INDESIT company

Model type:
LI42

Commercial code:
F027244

Notices

n1045034: New top condenser.

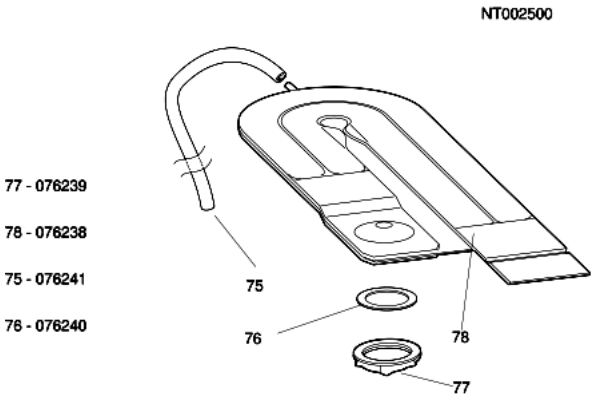
As of the last week in July 2000, the new "Wind drying system" was inserted on some appliances from the new MarckII Range. This new system foresees the elimination of the lateral air-flow body and the insertion of a new system with top condenser.
The spare part numbers eliminated are as follows:

054927(Rohs 144335) - RING NUT FOR AIR-FLOW BODY
054928 - AIR-FLOW BODY
103689 - NOZZLE GASKET
057874 - TOP SOUNDPROOFING LAYER

Whereas the new spare part numbers are:

076238 - WIND DRYNG SYSTEM CONDENSER
076239 - CONDENSER RING NUT
076240 - TOP CONDENSER GASKET
076241 - TOP CONDENSER PIPE

The new part numbers are not interchangeable with the old ones, as they are completely different. See technical drawing attached to notice NT002500.

Photo N1045062FIG1 illustrates the bottom of the dishwasher with EVO structure.

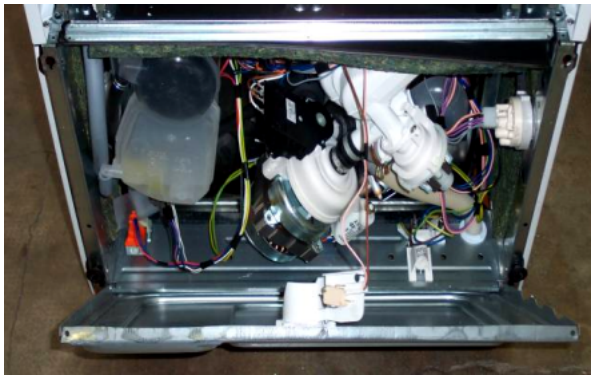
n1045062: Introduction of a new DW EVO structure

From serial number 30101.0001, all dishwasher models affected by this modification have been produced with EVO structure. These models have been equipped with NEW TRAYS AND NEW FEET (see N1045062TAB1).

PREMODIFICATION:
Tray: 083625 (for commercial code 28490) 078809 (for commercial codes 26043-23520-28088);
Tray rear feet: 078396-078397-078385;
Tray front feet: 073972;
Front feet supports: 065836(Rohs 143584);
Feet supplied with plinth accessories assembly: 034261;

EVO STRUCTURE:
Tray: 092558 (for commercial code 28490) 092554 (for commercial code 26043-23520-28088);
Tray rear feet: 092820-092821-092822;
Tray front feet: 092555;
Front feet supports: 065836;
Feet supplied with plinth accessories assembly: 034261.

Regulation assembly DX/SX Sat codes 078397 and 078396 will be managed up to stock end, after that they will be replaced by new Sat codes 092821 and092820. The same is for rear foot Sat code 078385 which will be replaced by Sat code 092822.

N1045063

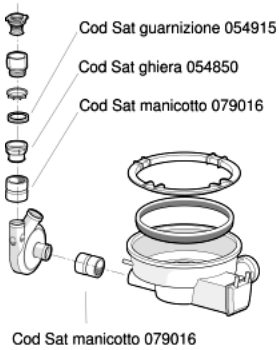
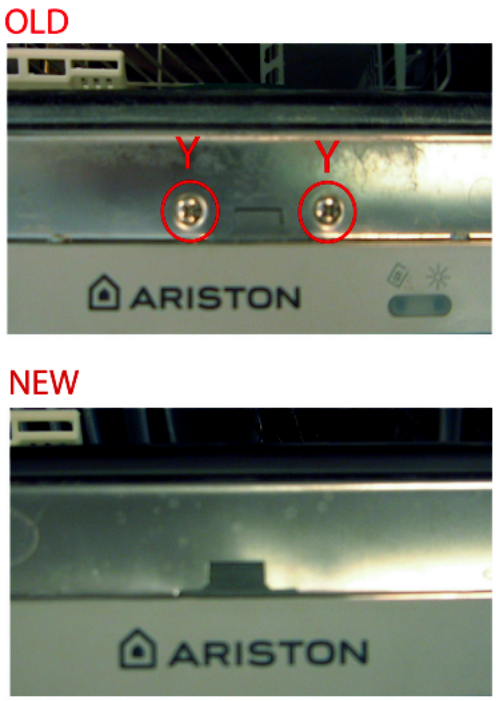
n1045063: Introduction of coupling+ring nut Sat code 093752

From serial number 30224.0001, all dishwashers affected by this modification have been equipped with the new coupling+ring nut assembly Sat code 093752, in place of coupling Sat code 079016, ring nut Sat code 054850 and gasket Sat code 054915.

Ring nut Sat code 054850 will continue to be available from the spare parts warehouse while stocks last, and coupling Sat code 079016 will continue to be stocked because it is still used for the tank-volute connection.
Picture N1045063 illustrates the premodification structure in FIG1 and the new structure in FIG2.

FIG. 1
STRUTTURA
PREMODIFICA

FIG. 2
NUOVA
STRUTTURA
